GROSSMAN
 POLE SHED

512 Warren Ave

APPLICATION FOR PERMIT

To construct 28' x 100' open storage shed for lumber

STORAGE MEZZANINE

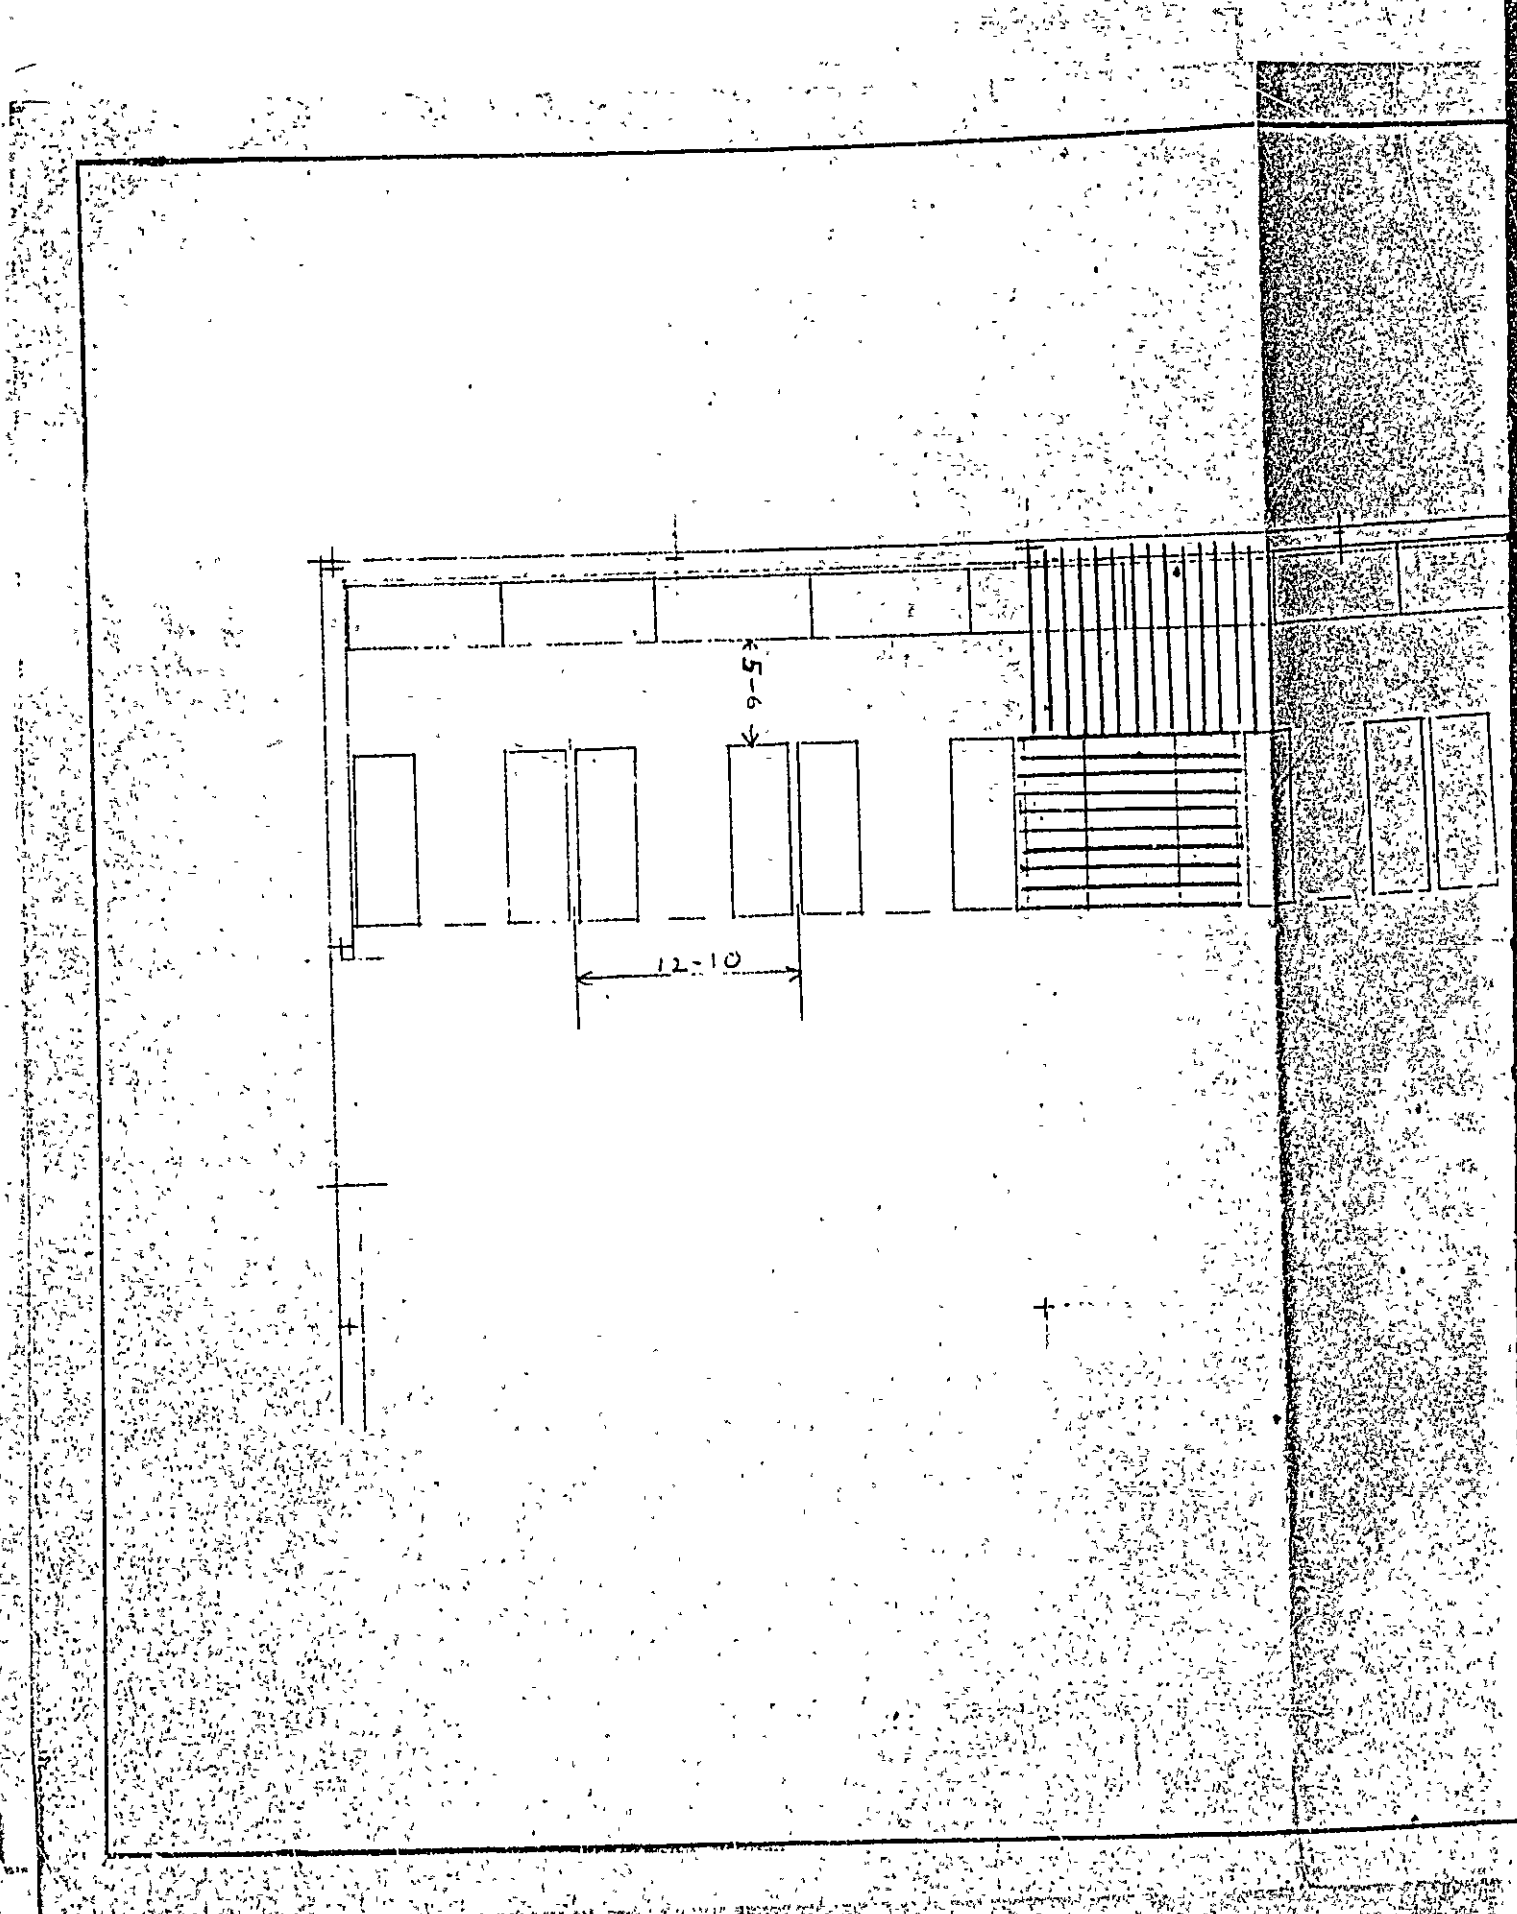
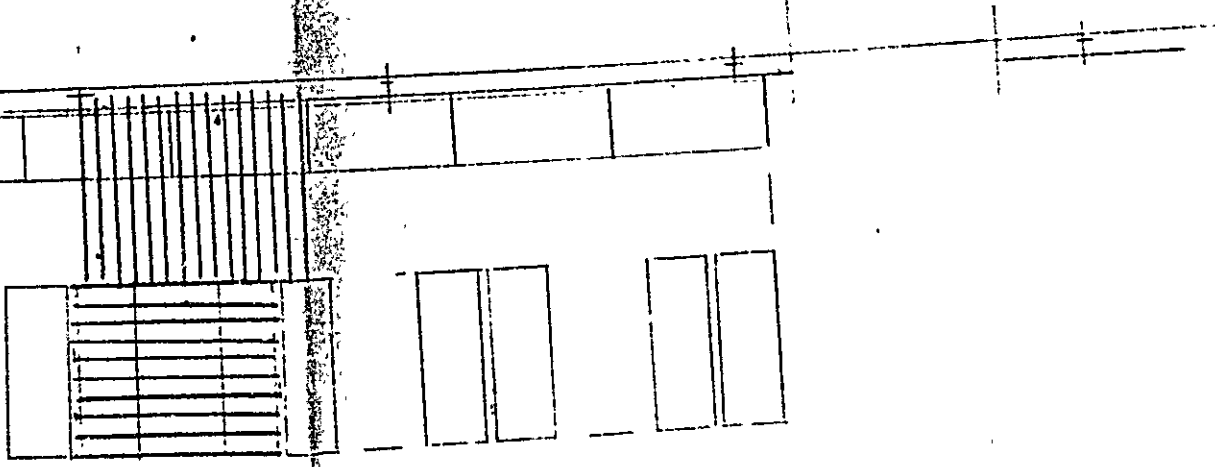
We are in receipt of sketches and computations for the storage mezzanine for the Grossman Store at the above address.

We call your attention to Section 306-a-10 of the Building Code. Before such floors or part thereof are occupied, and before a certificate of occupancy for a building or part thereof containing such floors is issued, permanent signs shall be posted, clearly legible from all parts of the floor areas involved, indicating the safe live load per square foot for which the floor is constructed.

We are in receipt of your signed design certificate for the mezzanine. If your local representative would make this application, at the same time give an estimated cost for same, and pay the fee based on this cost we would be in a position to process your amendment, without which we will not be able to issue a certificate of occupancy for the building.

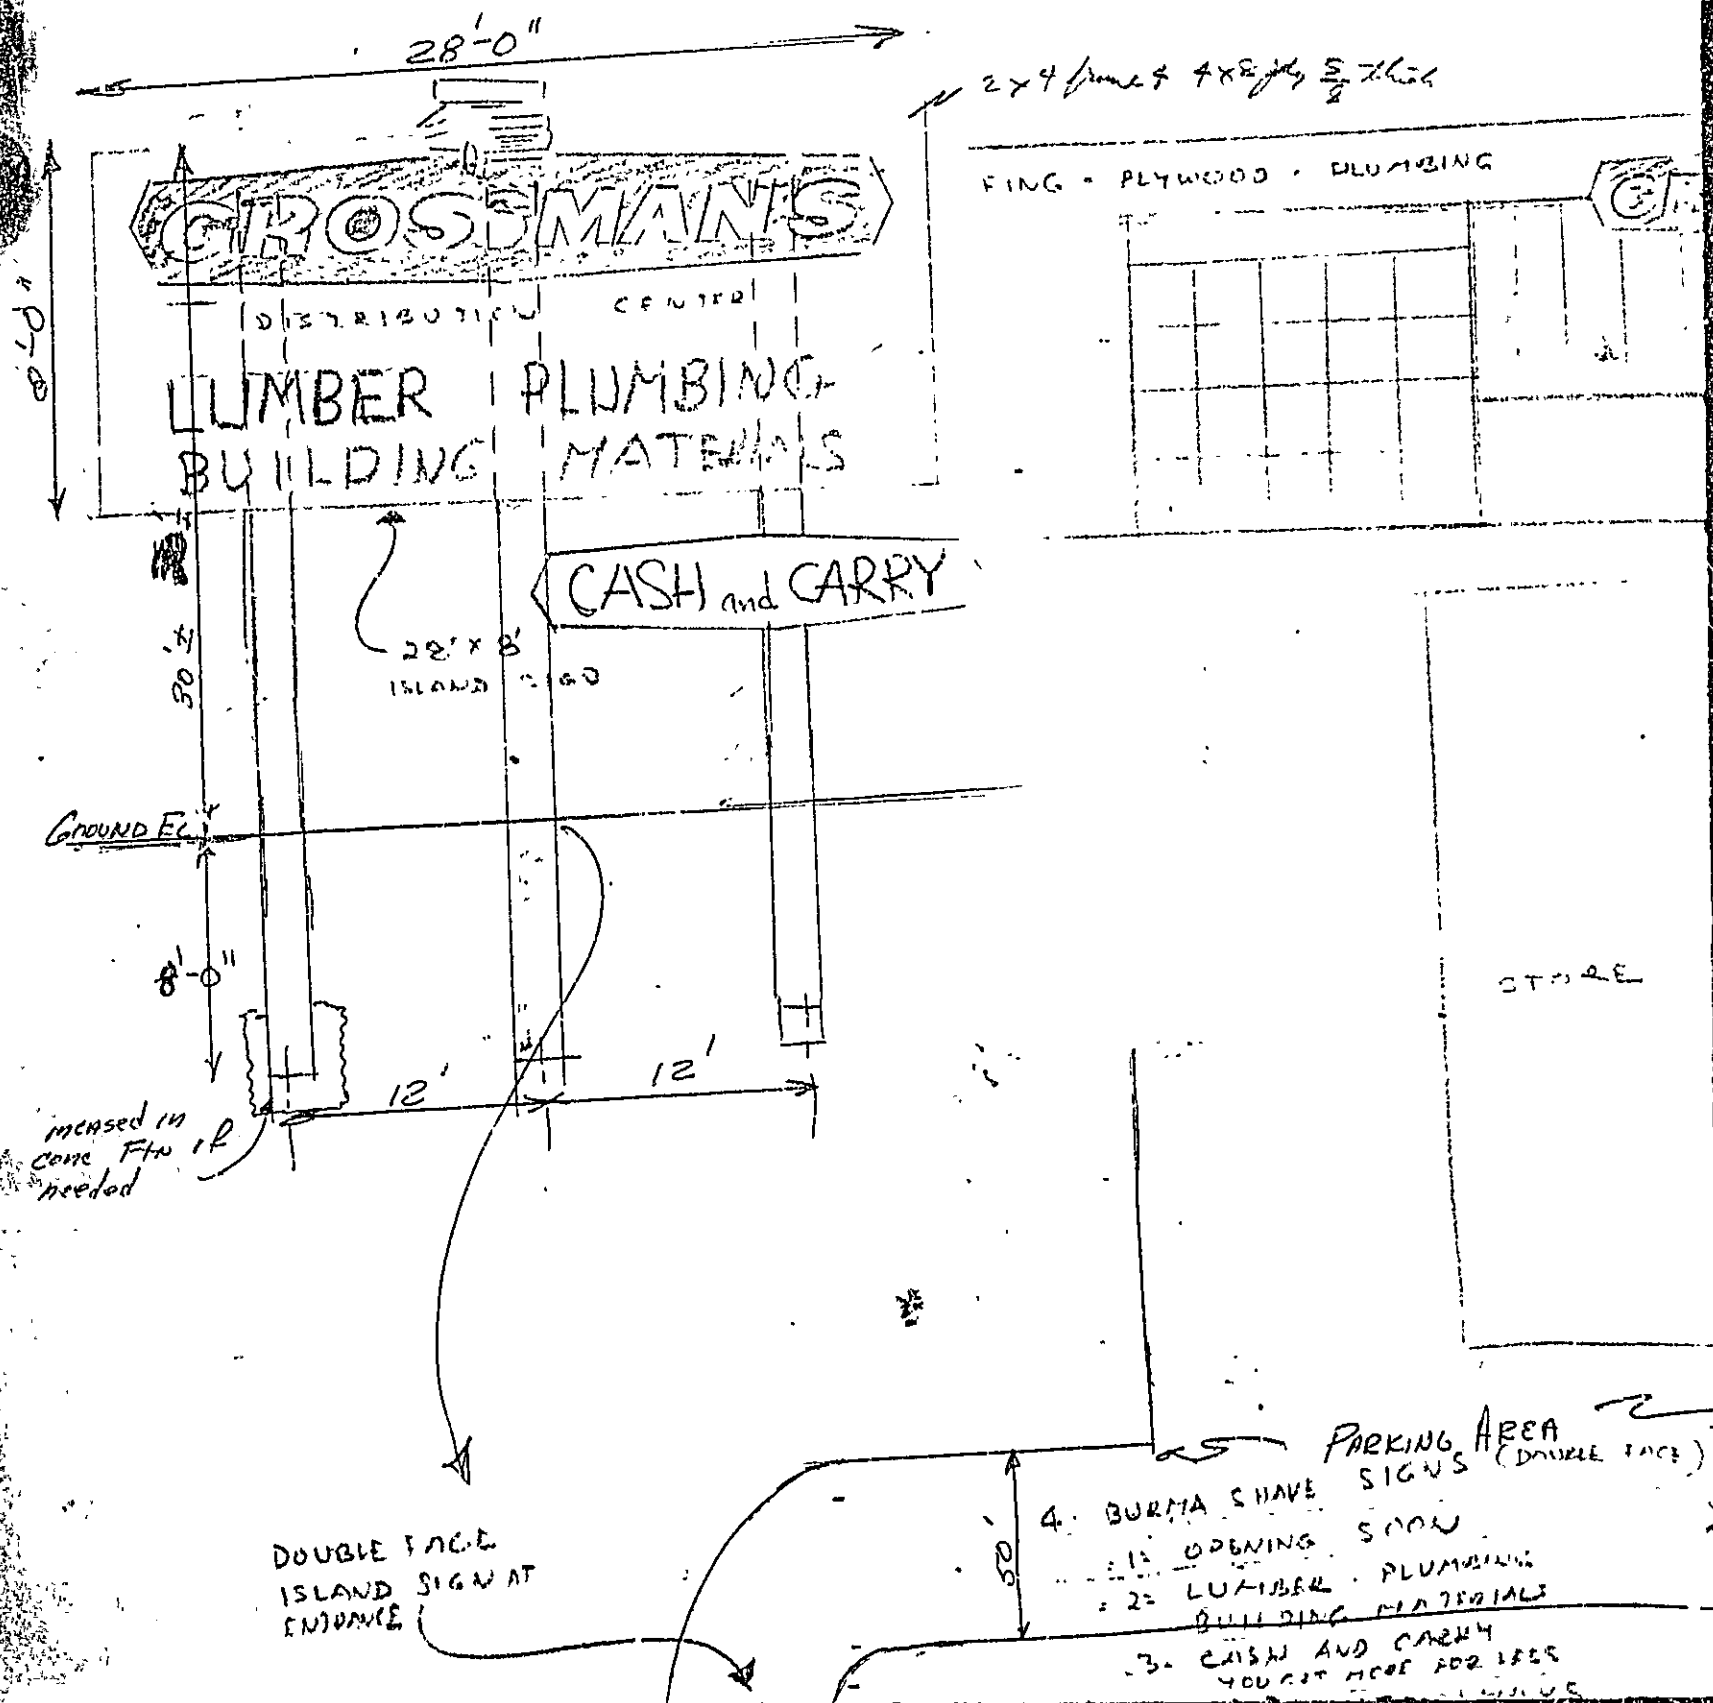
1. We understand that the detached sign is to be built as per your plans with the exception that the 2x4 inch horizontal stiffeners are to be added halfway between the two sets of stiffeners shown and that the sign faces are to be of metal. This sign is to be externally illuminated by gooseneck fixtures with wire being placed in conduit.

2. No part of the four 4x8-foot detached signs are to be located within the Warren Avenue right-of-way.
